## CHAPTER 8.0 LETTERS OF PUBLIC COMMENT AND RESPONSES AND REVISIONS TO THE DRAFT EIR

This chapter contains all public comments received on the Draft Environmental Impact Report (DEIR) and County responses thereto. Section 8.1 contains a list of commenters (Table 8-1) and a summary of changes made to the text of the DEIR and technical reports (Table 8-2). Section 8.2 contains the comment letters received and the County's responses to those comments.

Photo 4. Fry Creek running through the northern portion of the property. No Pond Turtles were found or are anticipated to occur in this area.

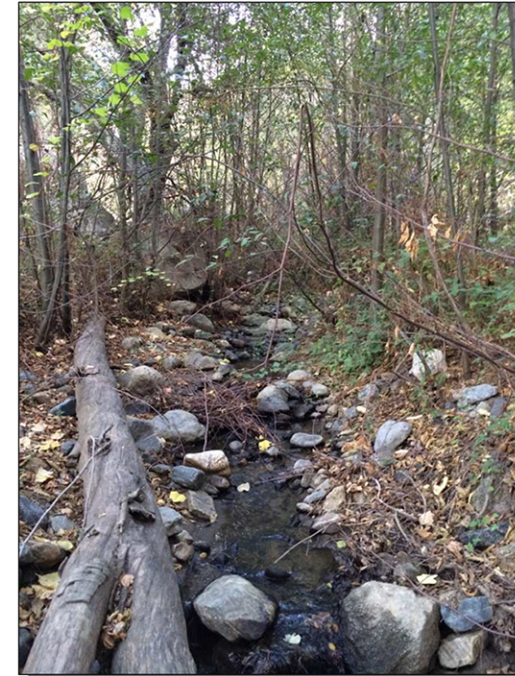
2. The final EIR should disclose whether any suitable habitat for cactus wren and/or southwestern pond turtle exist on-site and any potential impacts to these state species of special concern. The cactus wren (*Campylorhynchus brunneicapillus*) has been known to occur in the area southeast of the Project site and the biology report (Table 4-Observed Species List-Flora) notes the presence of *Opuntia* (cactus) species on-site but does not discuss its potential to provide nesting and foraging habitat for cactus wren. The southwestern pond turtle (*Emys marmorata*) is the state's only native freshwater turtle and can occur in streams, ponds and other small bodies of water and lake habitat, all of which exist on-site.

10. The County concurs with the comment. A focused search for the Southwestern Pond Turtle (SWPT) and SWPT habitat was completed by the project biologists on November 18, 2014. The memo covering the additional survey work carried out is attached to this letter and is included as new Attachment F of the biological report for the project (Appendix C of the EIR). The species was not anticipated on this site due to a general lack of habitat. All potential habitat areas, including the water reservoir and upper reaches of Frey Creek, were surveyed and no SWPTs were found. The reservoir supports no turtles and little vegetation, and the upper reaches of Frey Creek are beneath a closed canopy. Therefore the site is considered unoccupied by the SWPT. In addition, the following text was added in DEIR Section 2.4.2.3 under Criterion 3 as a result of this comment:
